Regional Center Approval to provide for updated plans for a three-story entertainment venue, previously approved through 2024-REG-046.

STAFF REPORT

Case Number	2025-REG-016
Address (approx.)	238 and 240 South Pennsylvania Street
Location	Center Township, Councilmanic District # 18
Petitioner	Boxcar Development, LLC., by Timothy E. Ochs
Zoning	CBD-2 (FF) (TOD) (RC)
Request	Regional Center Approval for provide for updated plans for a three-story entertainment venue, previously approved through 2024-REG-046.

SITE PLAN - SCALE: 1" = 20'-0"

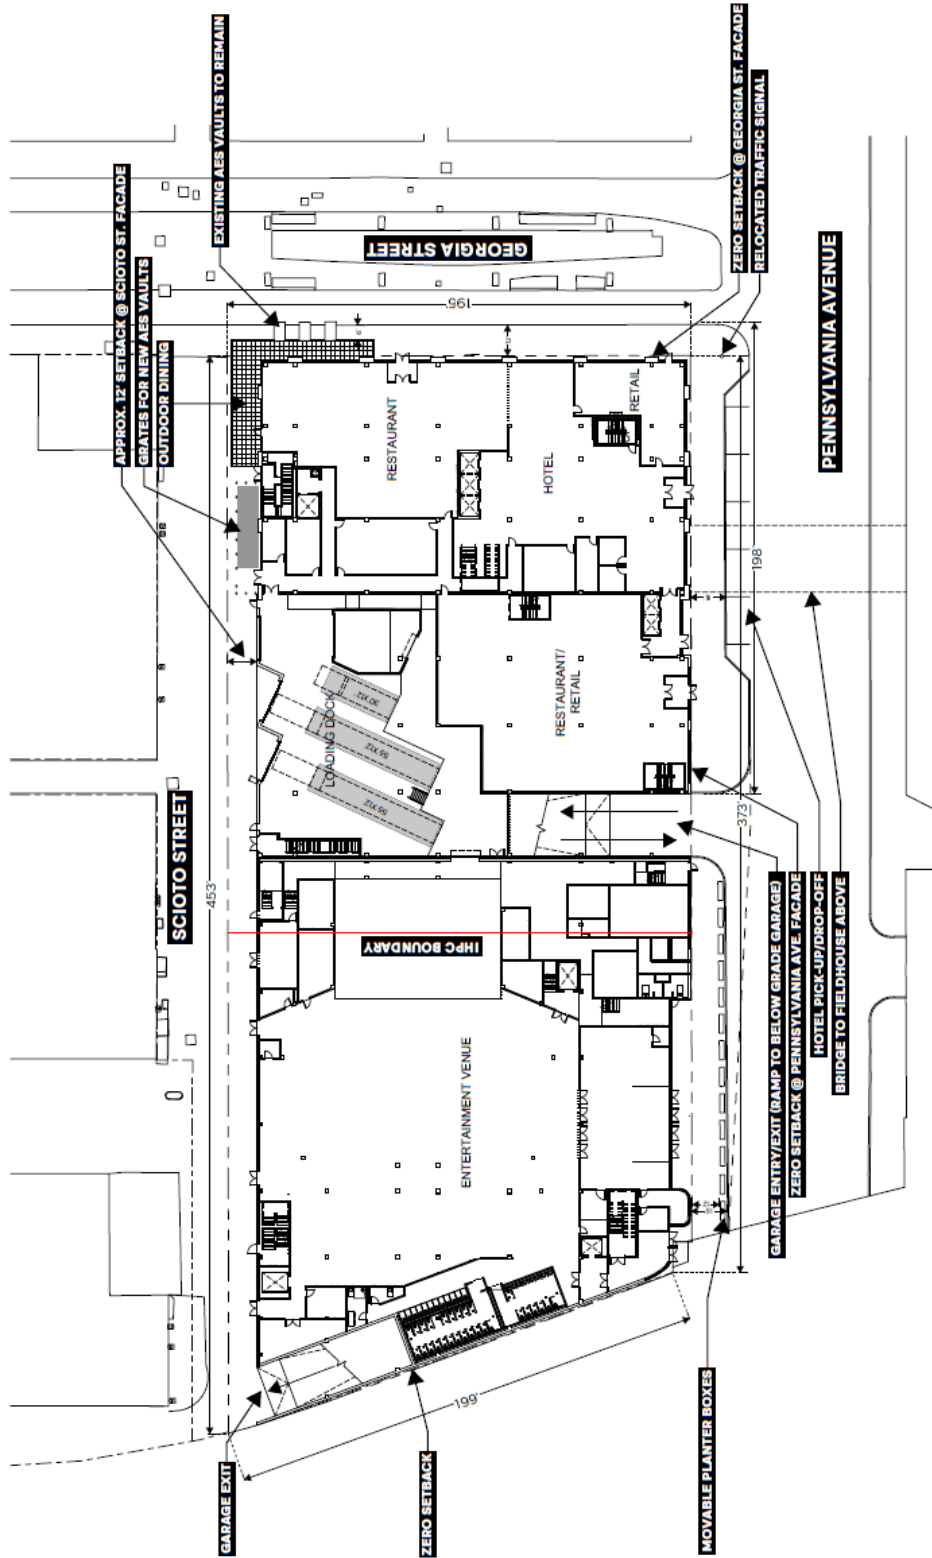
The proposed building material would be mostly brick, clear vision glass, and metal, with a marquee over the entrance to the facility. Previously, the entry proposed a canopy. The marquee is one change that is substantial, and supported as it quickly identifies the structure as an entertainment venue. Another change is the inclusion of vertical windows in the larger brick façade area, that previously had little interaction with the pedestrian way. A third change is the reduction of windows at the entrance to the facility. Additionally, the roof would be usable for events and gatherings, with a potential of an art piece. The site plan indicates a number of movable planter boxes along the street. No details of these planter boxes were submitted to the file.

EXTERIOR DESIGN MATERIALS - EAST ELEVATION

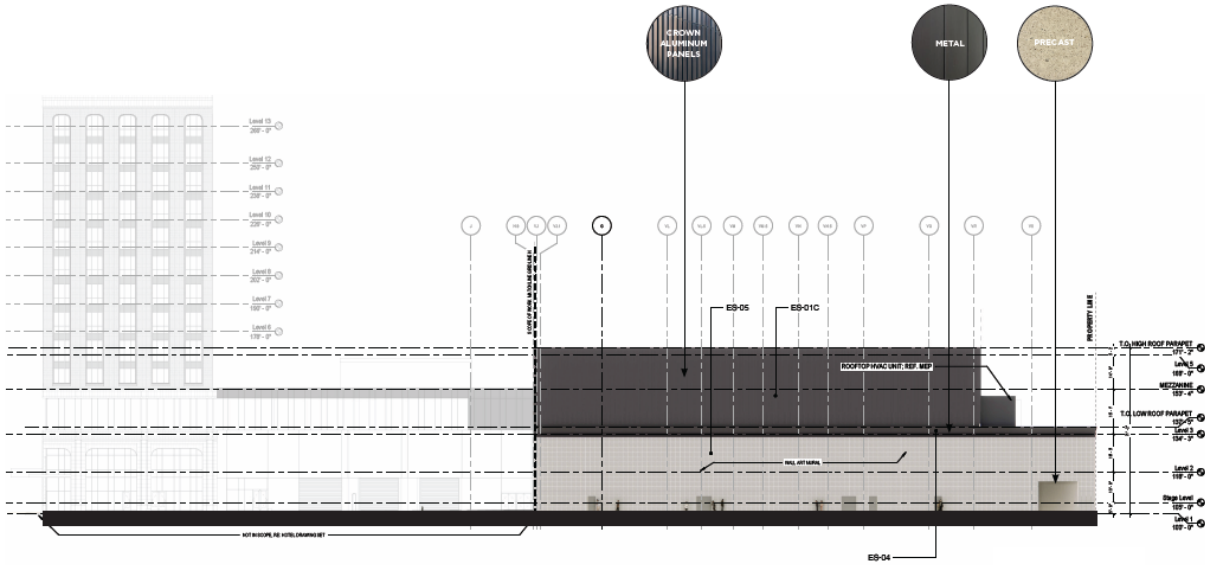
1. The revised design is an improvement over the previously approved design in that new windows are proposed in an area that previously would be large brick wall, with little interaction with the pedestrian way. Staff would request details to be submitted of the proposed east elevation 'wall art mural' before installation. Guideline CA 1.2.1 applies.

1. The Summary items shall be met.
2. That 'wall art mural' details for the east elevation shall be submitted for staff review and approval prior to installation.
3. All signage within two years of MDC approval requires planning staff review and approval. After the two-year period, a new Regional Center Approval petition would be required for review and subsequent approval of any proposed signage.
4. Address numerals shall be installed on the building façade (CA 2.5.8) prior to occupancy of the building.
